City of Flowery Branch
City Council Meeting
Thursday, September 4, 2025, 6:00 PM
5410 Pine Street
Flowery Branch, GA 30542

Memorandum

From: Planning and Community Development

Proposed Site Plan

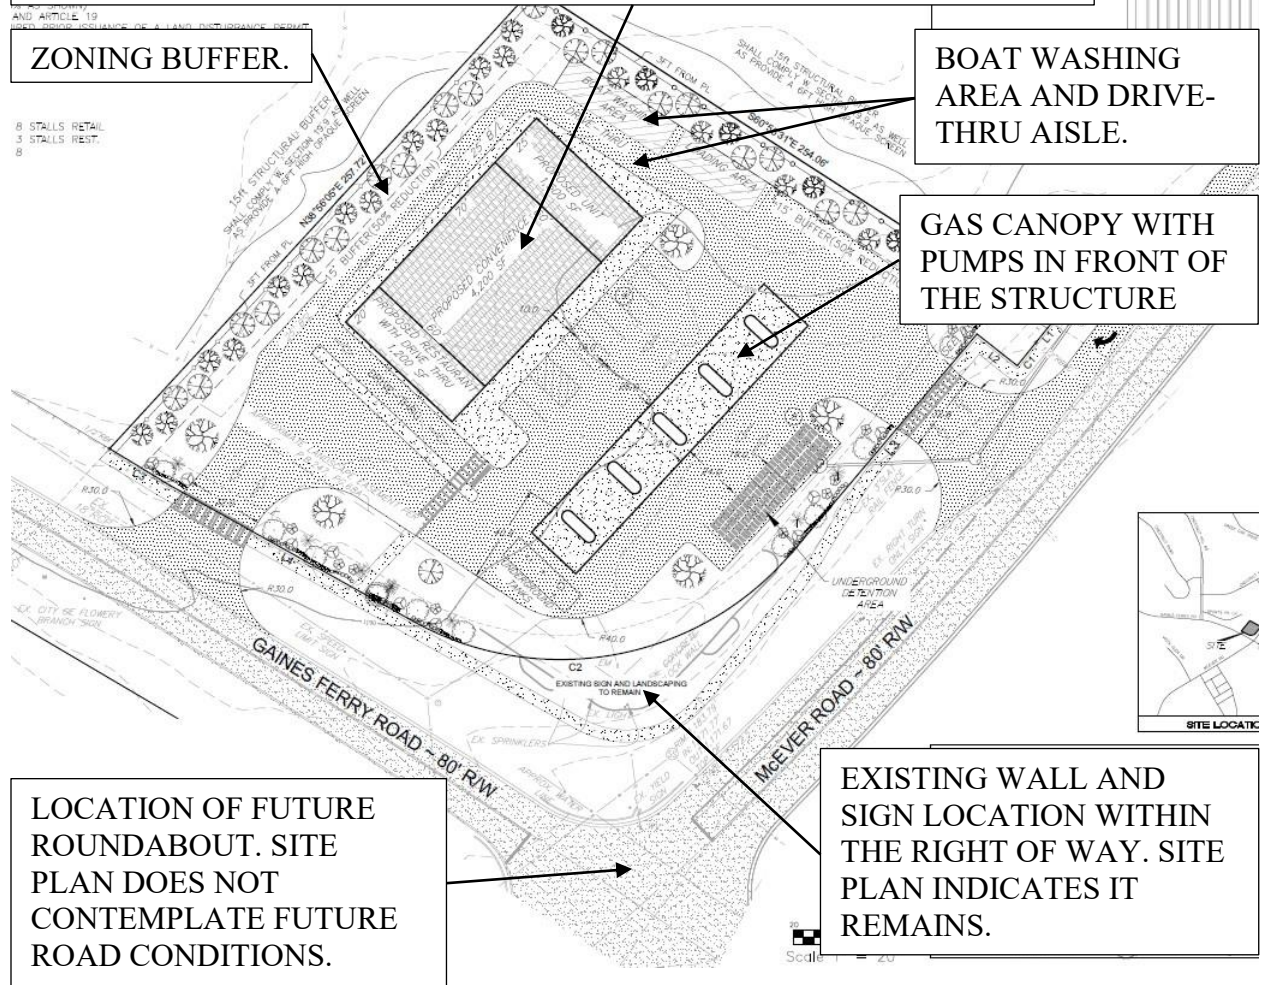
ZONING BUFFER.

BOAT WASHING AREA AND DRIVE-THRU AISLE.

LOCATION OF FUTURE ROUNDABOUT. SITE PLAN DOES NOT CONTEMPLATE FUTURE ROAD CONDITIONS.

EXISTING WALL AND SIGN LOCATION WITHIN THE RIGHT OF WAY. SITE PLAN INDICATES IT REMAINS.

The plan design will be in conflict with the upcoming roundabout. The entrances shown will likely need adjustments and limits on incoming and outgoing travel. For example, both entrances will need to be right in – right out with a curbed median to avoid illegal left turns out of the site if approved.

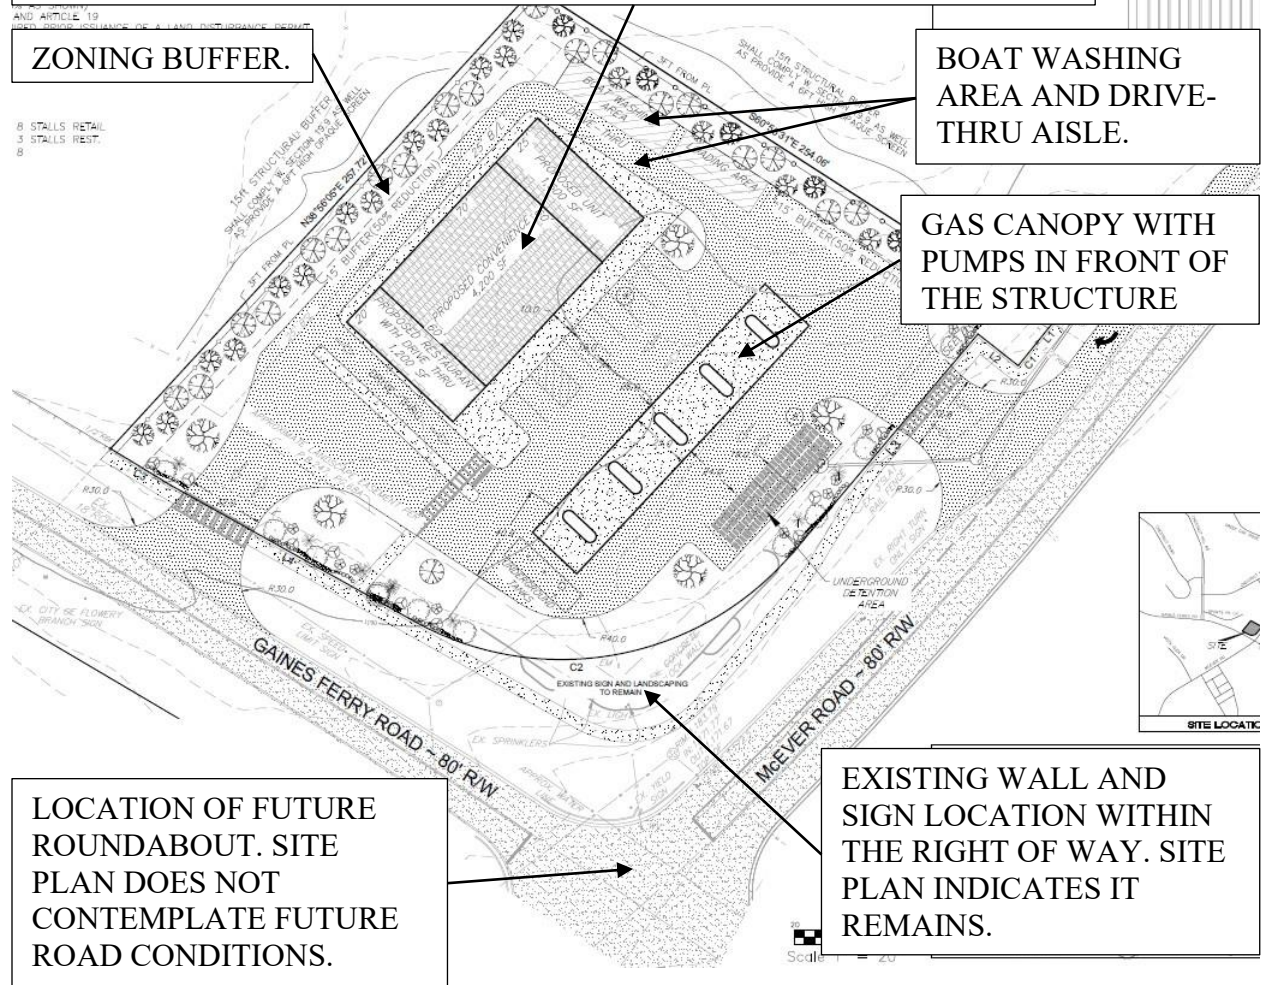
ZONING BUFFER.
